Access Compliance Report Public Rights-of-Way (Curb Ramps)

Main Street: LULLABY_LN		Cross Street: POONA_DR		Location:	NW
ADA ID: RPAT220203155032	Ramp Type: Type 4 - Parallel	Initial Pass/Fail: Pass	Overall Compliance: No	Severity Score:	5
Codes/Mitigation Info/Possible Solution			Field Measurements/Component Compliance

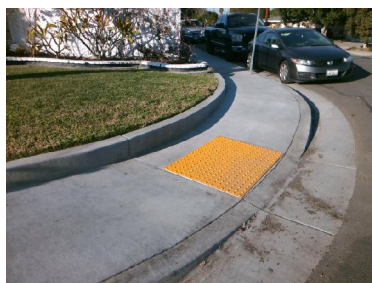
Remove & Replace Curb Slope. Remove & Replace Gutter.

Crossing 1 Slope (%)	3.8		Crossing 2 Slope (%)	N/A
	Crossing 1 Cross Slope (%)	5.5		Crossing 2 Cross Slope (%)	N/A
Yes	Gutter Ponding	No	No	Curb Slope	8.4
Yes	Gutter Lip Height (in)	0		Road Run Slope (%)	N/A
No	Gutter Run Slope (%)	6.3		Road Cross Slope (%)	N/A
Yes	Gutter Cross Slope (%)	1.3	Yes	Perpendicular Joint Present	Yes
Yes	Overall Surface Condition	Acceptable			
	Cross Gutter Present?	No		Spandrel Present?	No
	Replace Cross Gutter?	N/A		Replace Spandrel?	N/A

R304.2.2, R304.5.4, STD 1115
